CHANGE ORDER APPROVAL FORM

PROJECT: CR121 Pond Reconstruction CHANGE ORDER NUMBER: 01
DATE: 11/09/10
CONTRACT NUMBER: CM16

PROJECT: CR 121 Pond Reconstruction

CR 121 DRAINAGE/POND DESIGN
RETENTION POND DETAIL

SHEET NO. **13**

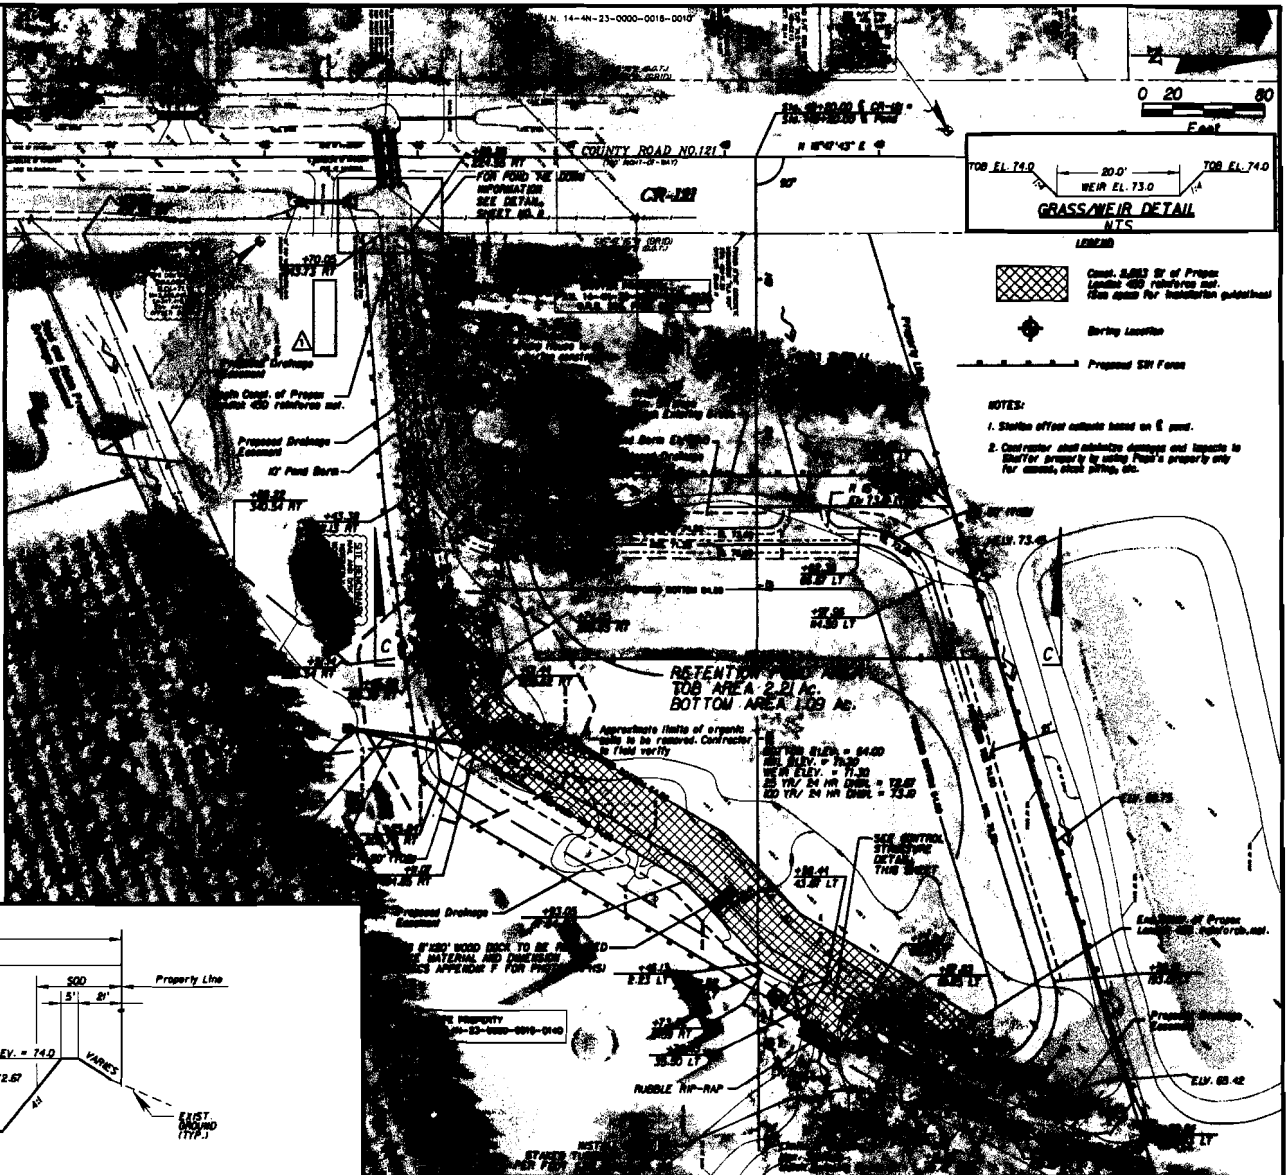
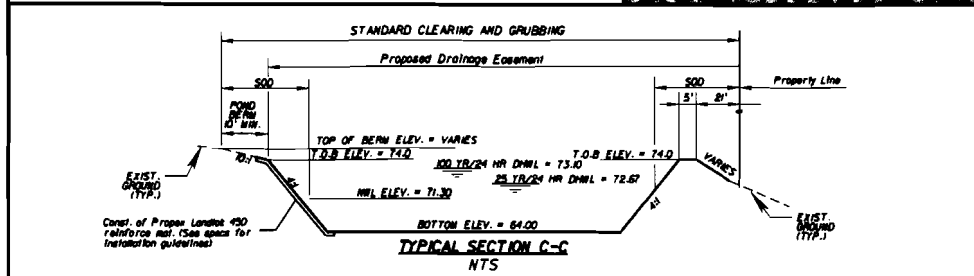
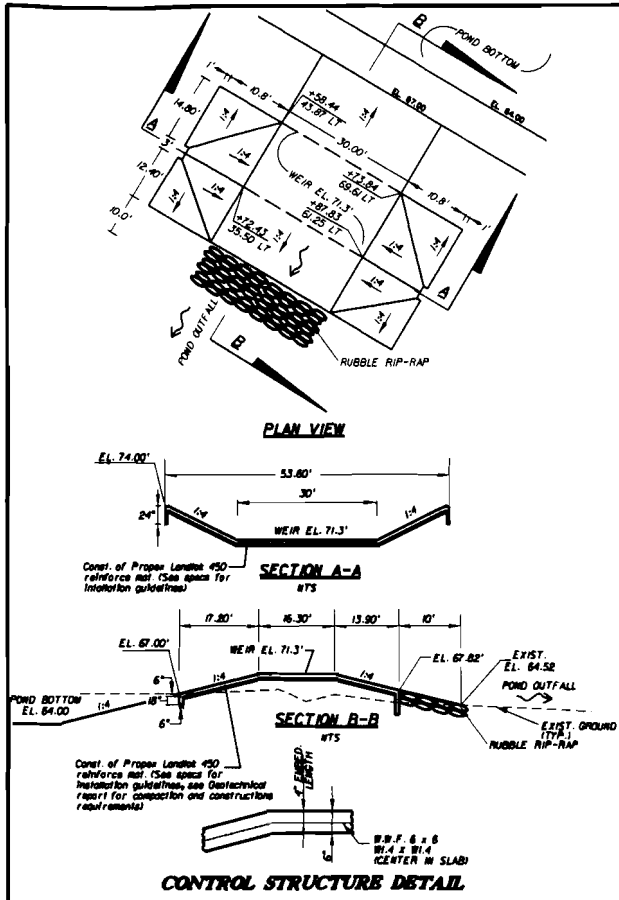
Reason for Change Order: Plan sheet 13 revision dated 10/16/10 (pond size and configuration changes) and discovery of highly organic material at existing pond bottom.

REVISIONS	
DATE	DESCRIPTION
07/19/10	RELOCATION OF THE S.T.P.D.
10/16/10	RELOCATION OF PROPOSED TUB REVERSE PIPE INVERTS AND LOCATION

Comment : Please verify the north invert of the 15" RCP pipe run has sufficient cover. In addition, the north invert needs to be relocated approximately 20' to the west to avoid a large diameter tree that is to remain. Please include any additional pipe that will be required to make this adjustment and keep the MES in the pond slope as originally intended. Also, since the MES is shallow, please look at the need for Riprap at this location if so indicated by flow calcs.

Comment : Due to the relocation of the north MES we feel it will be necessary to add concrete slope pavement on the east bank of the existing swell ditch at the south MES to eliminate any under mining and potential wash outs.

Comment : At the 20' wide grass/weir, please review flow calcs to verify that RipRap will not be necessary at this location.

Comment : One final comment the contractor asked if we had considered/need any riprap or erosion protection where the "ditch" "dumps" into the pond on a 1:4 slope due to the sandy soil conditions in the pond...

Please verify the north invert of the 15" RCP pipe run has sufficient cover. In addition, the north invert needs to be relocated approximately 20' to the west to avoid a large diameter tree that is to remain. Please include any additional pipe that will be required to make this adjustment and keep the MES in the pond slope as originally intended. Also, since the MES is shallow, please look at the need for RipRap at this location if so indicated by flow calcs.

Due to the relocation of the north MES we feel it will be necessary to add concrete slope pavement on the east bank of the existing swell ditch at the south MES to eliminate any under mining and potential wash outs.

At the 20' wide grass/weir, please review flow calcs to verify that RipRap will not be necessary at this location.

Looks like it addresses our concerns to me, how about you guys? Maybe need some rip-rap at the outfall of that MES feeding the pond? We also have no cover if the invert is one tenth below the TOB. In fact we have a protrusion? That is in the maintenance area too. Maybe Daryl can drop that invert to 71 or 72 and decide if he needs Rip-Rap or not based on the computed flow there in the 25 year storm.

Attached please find revised "Retention Pond Detail" sheet and AutoCAD file. Proposed TOB North/East/West limits were relocated, Grass/Weir was included to accept west site drainage.

110-1-1 Clearing and Grubbing = 3.2 Ac. ←
 120-1 Regular Excavation = 9,732 C.Y.
 120-6 Embankment = 3,120 C.Y.
 400-2-1 Class II Concrete (Control Structure) = 47.8 C.Y.
 415-1-5 Reinforced Steel (Substructure) = 520 LB.
 430-174-101 Pipe Culvert (Opt Matl) (Up to 24") (Side Drain) = 127 L.F.
 570-1-2 Performance Turf (Sod Pond) = 3,990 S.Y. ←
 Propex Landlok 450 (Erosion Control) = 2,686 S.Y.

Respond : Invert elevation, pipe length and north MES were revised to provide additional cover and to avoid conflict with existing tree, RipRap and/or energy dissipaters are not applicable due to low velocities in the proposed drainage system. The pipe invert elevation is 71.7 and the pond NWL is 71.3.

Respond : The proposed pipe was adjusted slightly to align with the existing one to provide a more continuous (straighter) flowpath for runoff. Due to the amount of runoff coming to this pipe we don't feel that concrete ditch pavement is necessary.

Respond : Proposed west weir will provide inflow to the pond for the runoff only from Shaffer property, this parcel has significant pervious surface, as such low velocity/runoff are anticipated.

Respond : Longitudinal profile along the proposed ditch is 0.016 Ft/Ft, Normal Water Level El. 71.30 is estimated to be at the east section of the ditch, therefore "dumps" and/or hydraulic jumps are not anticipated based on proposed pond contours. The proposed ditch is to be part of the proposed pond.
